SUBJECT: Initial Draft of Performance Specification Sheet MIL-PRF-19500/746Dam5,
Project Number 5961-2026-044.

The initial draft of the subject document was generated to add an additional die version and to update it to the latest document format and various editorial changes to bring it into compliance with MIL-STD-961. Highlighting has been used for easy change recognition.

MIL-PRF-19500/746D
w/AMENDMENT 5
DRAFT
SUPERSEDING
MIL-PRF-19500/746D
w/AMENDMENT 4
11 August 2025

TRANSISTOR, FIELD EFFECT, RADIATION HARDENED, N-CHANNEL, SILICON,
SURFACE MOUNT AND UN-ENCAPSULATED, TYPES 2N7587, 2N7589, 2N7591, AND 2N7593,
QUALITY LEVELS JANTXV, JANS, JANHC, AND JANKC

FIGURE 2. JANHC and JANKC (A-version) die dimensions.

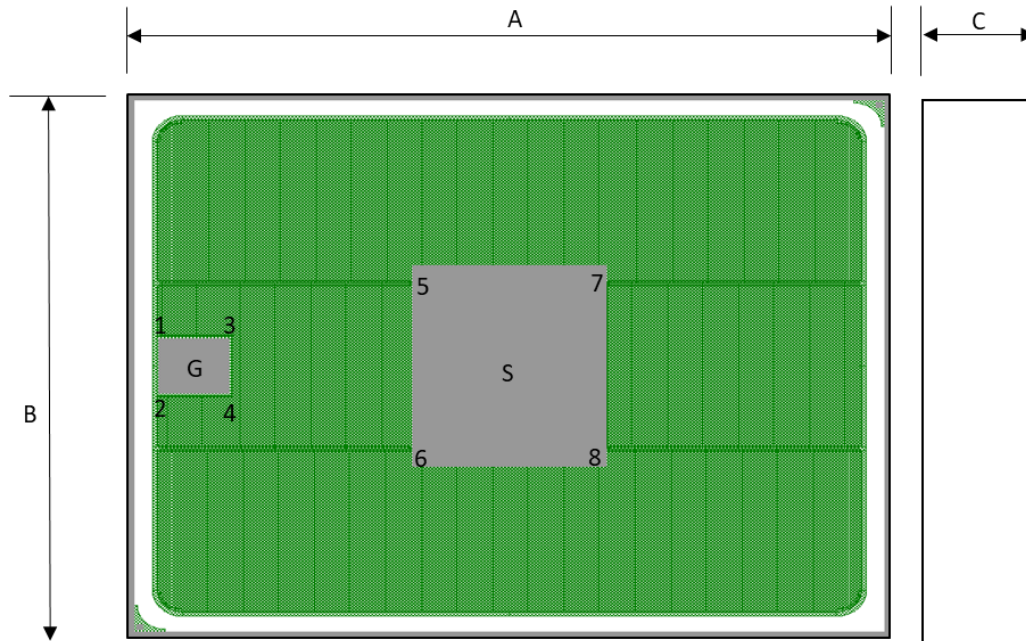
* 1.5.6 Die identifiers for un-encapsulated devices (manufacturers and critical interface identifiers). The manufacturer die identifier that is applicable for this specification sheet is "A", [and "B"](#), [and "C"](#) (see [figure 2](#), [figure 3](#), [figure 4](#), and [6.5](#)).

FIGURE 3. JANHC and JANKC (B-version) die dimensions.

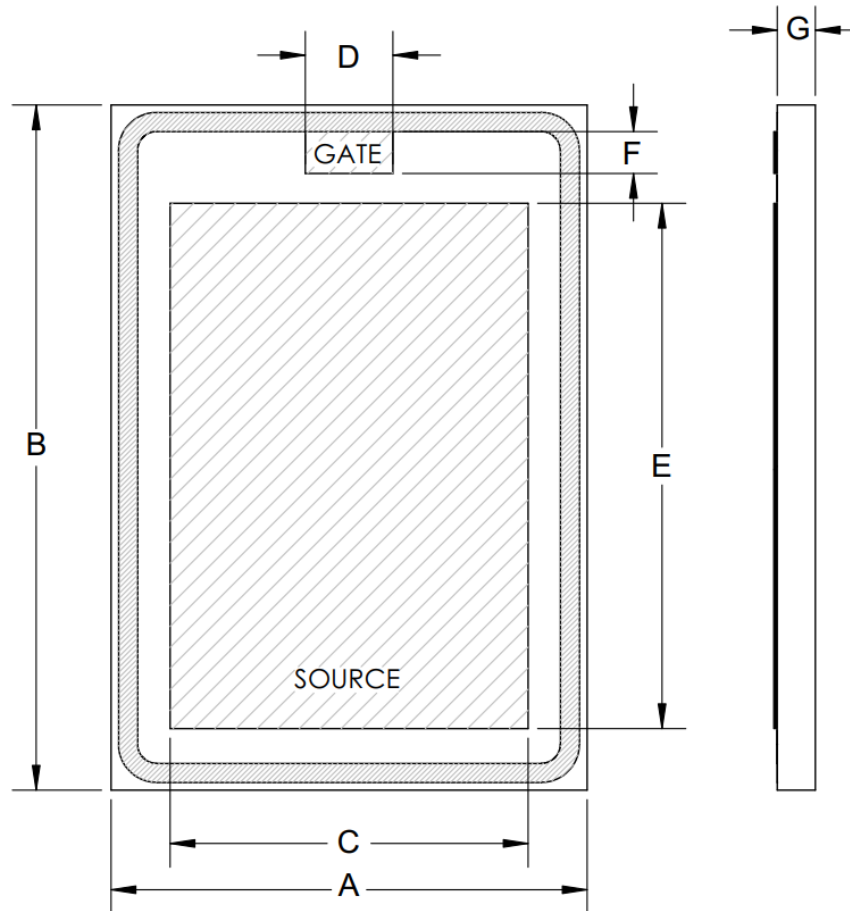
* 1.2.2 Die dimensions and topography. The dimensions and topography for JANHC and JANKC unencapsulated die are in accordance with [figure 2](#) and [figure 3](#), and [figure 4](#).
